Product Change Notification / MFOL-04PKQY369

CCB 4630.002 Final Notice: Qualification of STA as an additional assembly site for USB3340-EZK, USB3340-EZK-TR, USB3370B-EZK and USB3370B-EZK-TR catalog part numbers (CPN) available in 32L VQFN (5x5x0.9mm) package.

CCB 4630.002
Pre and Post Change Summary
PCN# MFOL-04PKQY369

**QUALIFICATION REPORT SUMMARY
RELIABILITY LABORATORY**

Lead Frame Comparison

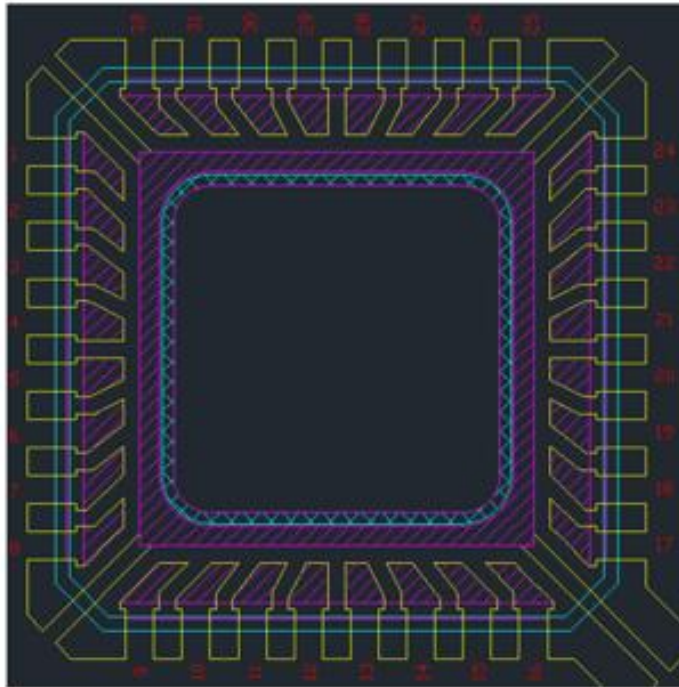
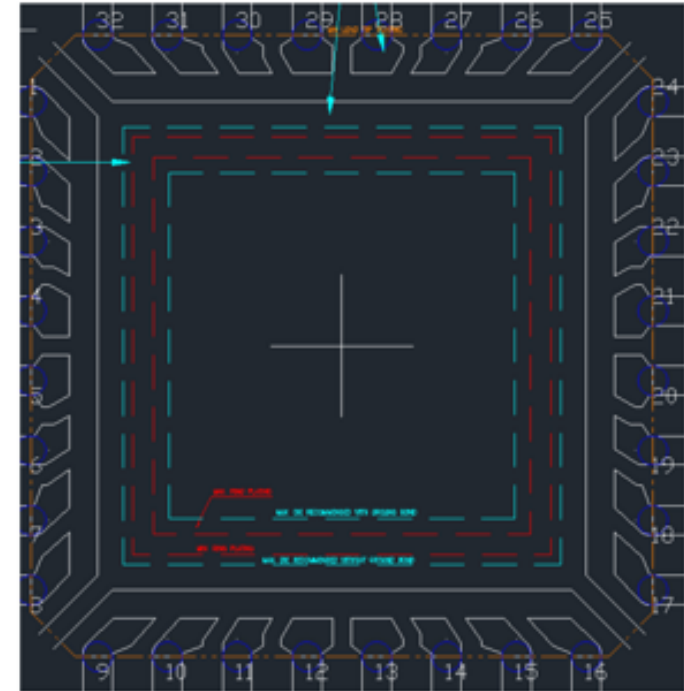
ASE

Lead frame
material

C194

STA

Lead frame
material

C194

Tray Comparison

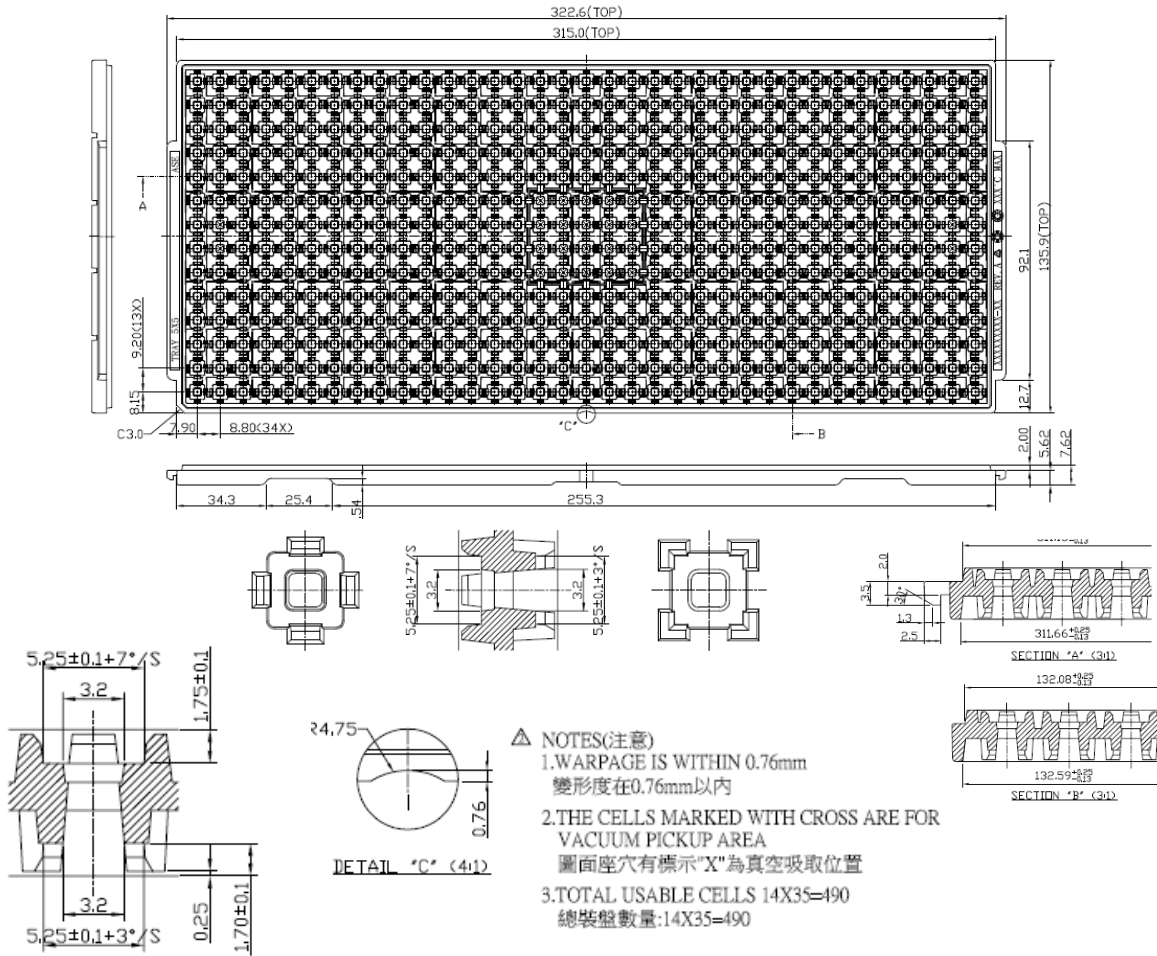
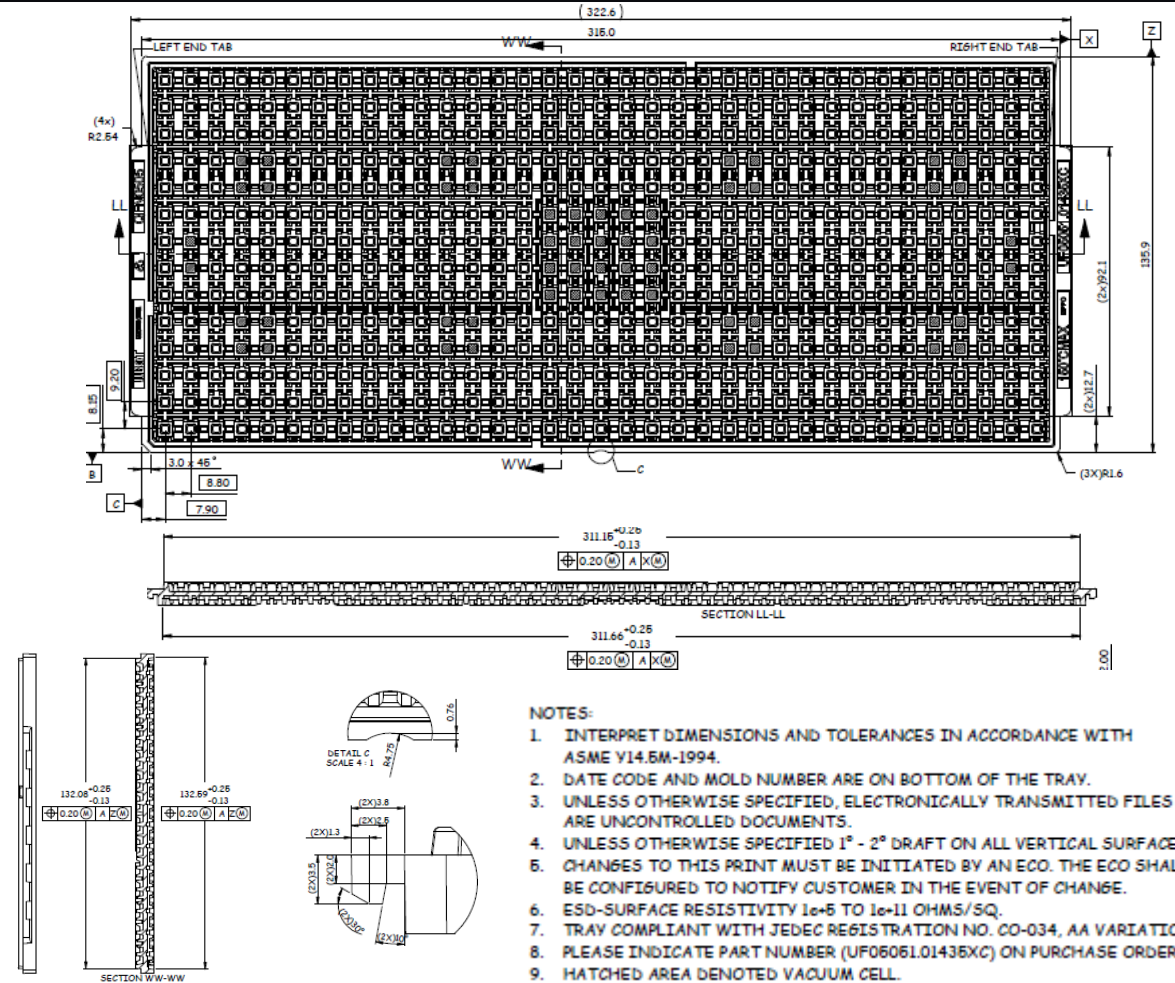
ASE

STA

Tray Vendor	Tray Part Number	Tray Temp	Row	Col.	Total Pocket (BQM)	Tray Width	Tray Length	Tray Thickness	Pocket Pitch (X)	Pocket Pitch (Y)	Outer Pocket center to tray edge (X)	Outer Pocket center to tray edge (Y)
ASE Tray	ASE Tray JT1050501-07 REV.A	150°C	14	35	490	135.9	322.6	7.62	8.80	9.20	7.90	8.15
STA Tray	UBOT Tray UF05051.01435XC	150°C	14	35	490	135.9	322.6	7.62	8.80	9.20	7.90	8.15
